**MIXED USE AND SENIORS LIVING
DEVELOPMENT**
5 Skyline Place Frenchs Forest NSW 2086
SP 49558

SCALE:	AS SHOWN	DRAWING DA101 ISSUE
SUBSET:	SITE PLAN	
DRAWN BY:	SUM/WH/SP

SECTION 4.55(8)

LEVEL 4 FLOOR PLAN

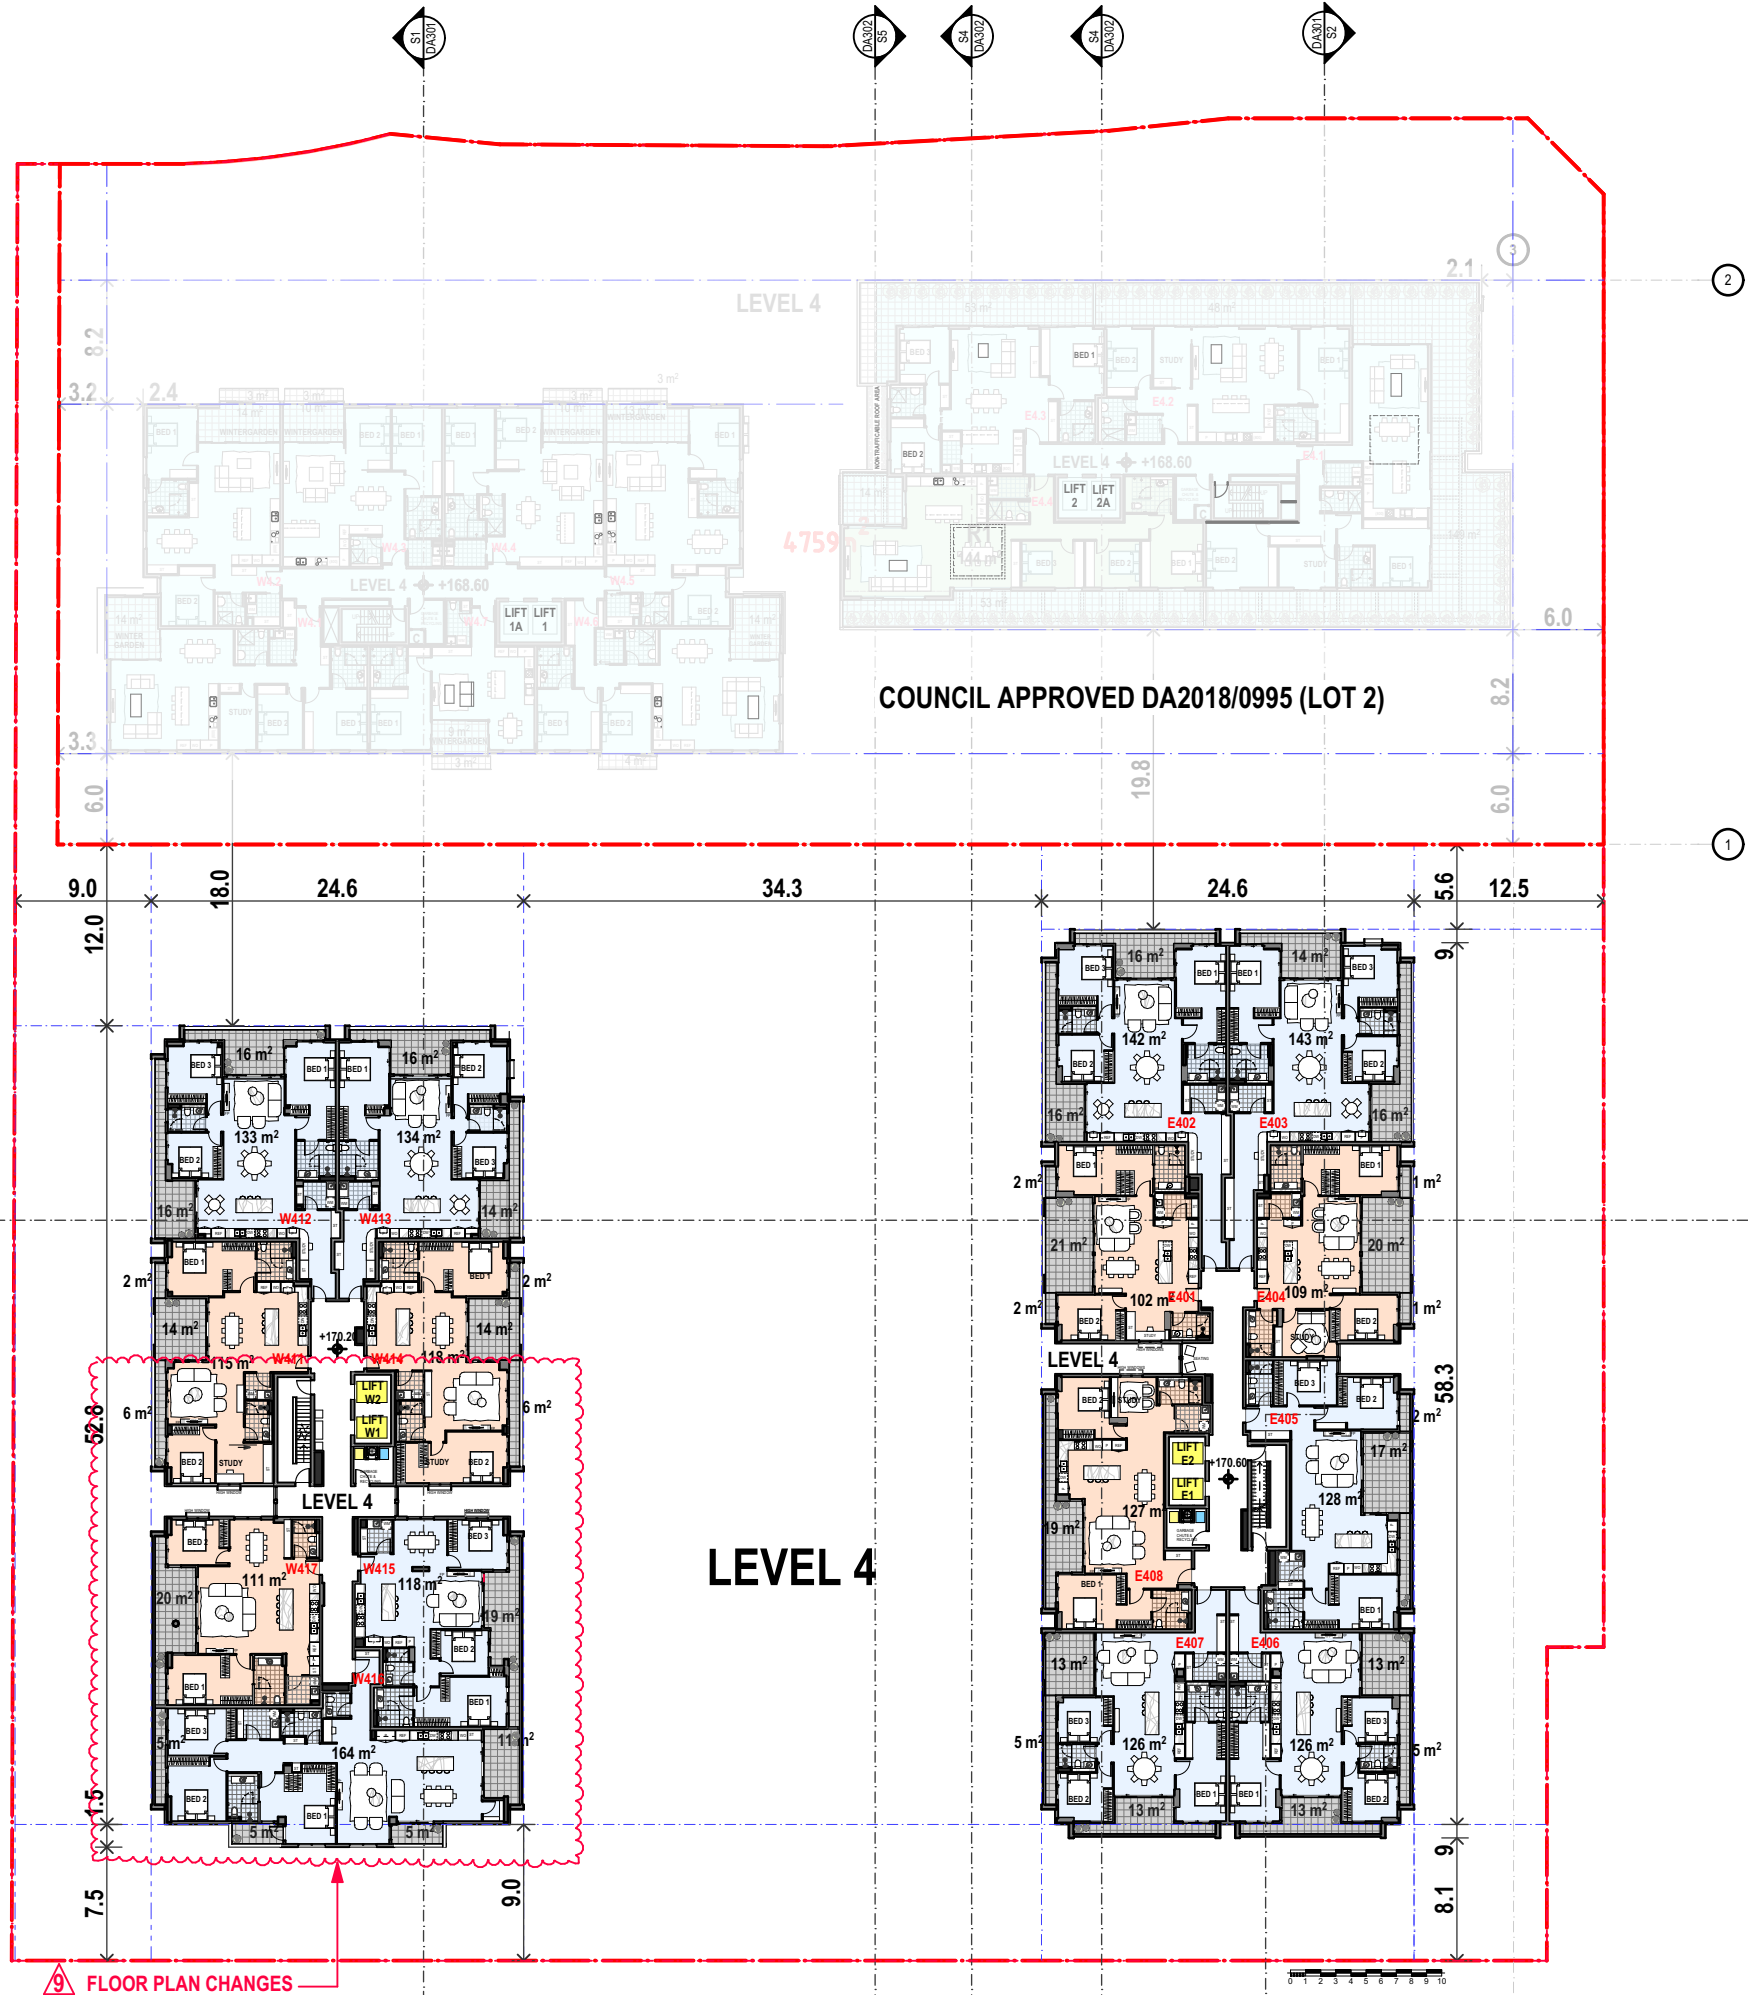
9 FLOOR PLAN CHANGES
